FIELD SERVICE BULLETIN #008

Problem: Excessive wear (metallic powder/metal particles) due to the cam followers of the latching operation coming in contact with the top front frame during opening and closing of the upper chassis.

Solution: Check and re-adjust the cam followers.

Fig. 1

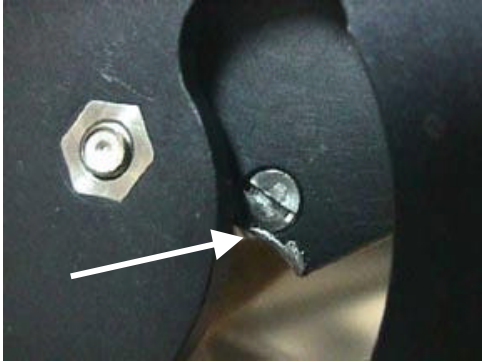
- ∑ Locate problem area and look for signs of excessive wear. (See Fig. 1)
- ∑ If re-adjustment is needed, remove both end covers.
- ∑ Measure from the front edge of the chassis frame to the front of the cam follower. (See Fig. 2) The location of the cam follower from the factory is all the way towards front of plotter, approximately 7/16".
- ∑ Loosen the cam follower using a 3/8 nut driver on the hardware located on the outside of the chassis frame, (See Fig. 3) and a screwdriver holding the body of the cam follower.
- ∑ Relocate the cam follower 1/16" towards the rear of the plotter and tighten hardware.
- ∑ When the cam follower is in the correct position, the front edge of the latch will be approximately parallel with the front edge of the chassis frame and the latch knob approximately 1/16"-1/8" away from the knife stiffener. (See Fig. 4 and 5)
